# CERTIFICATE OF SURVEY

PROPERTY ADDRESS: #300 Floral Drive  
Shoreview, MN

FOR: Paulson Construction

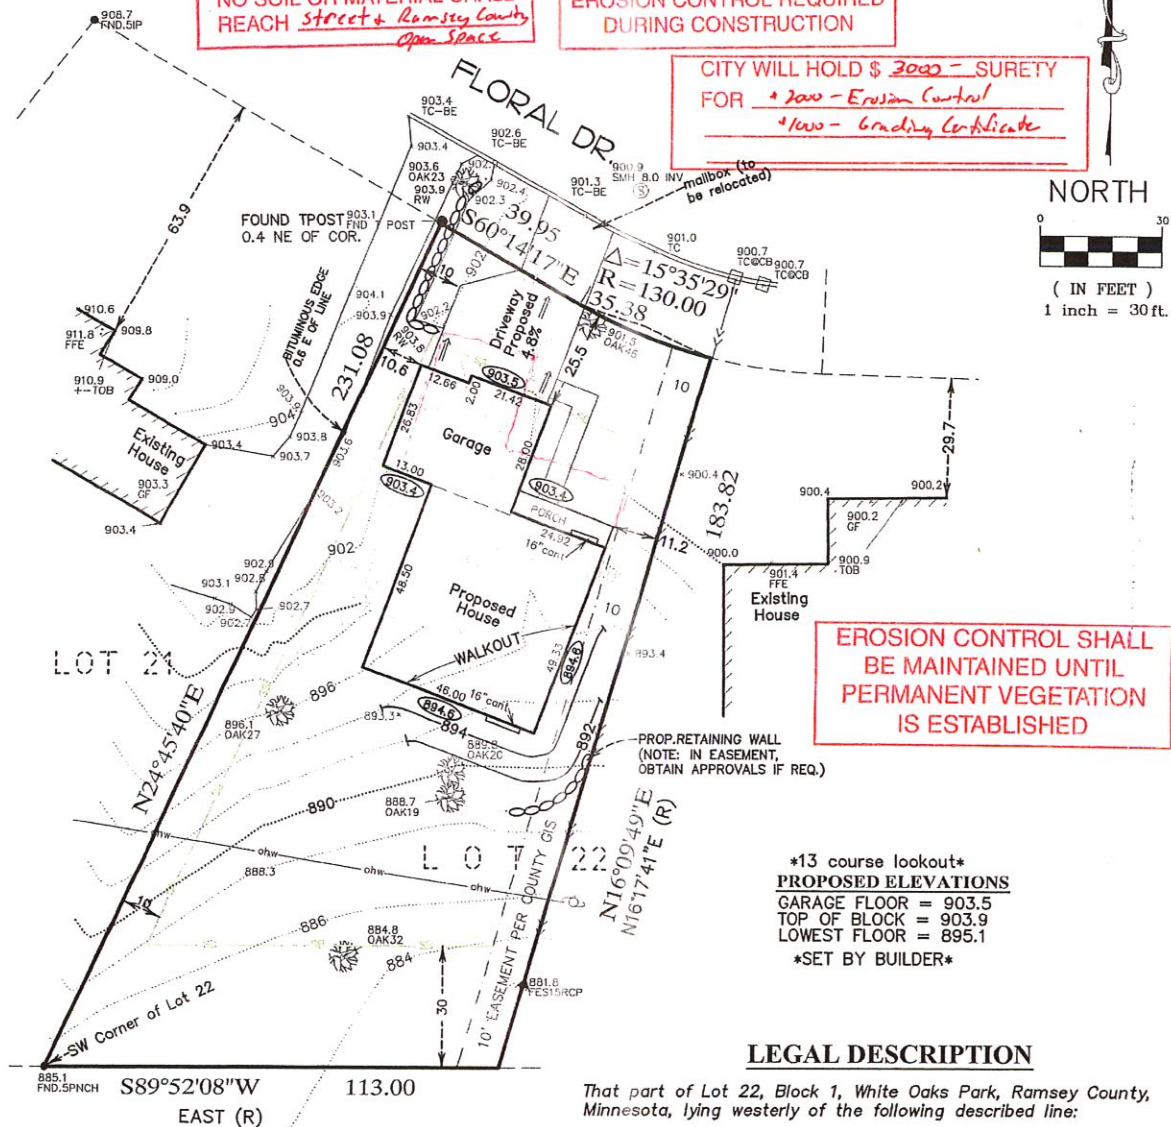
NO SOIL OR MATERIAL SHALL REACH street + Ramsey County Open Space

EROSION CONTROL REQUIRED DURING CONSTRUCTION

CITY WILL HOLD \$ 2000 - SURETY FOR +2000 - Erosion Control + 1000 - Grading Certificate

EROSION CONTROL SHALL BE MAINTAINED UNTIL PERMANENT VEGETATION IS ESTABLISHED
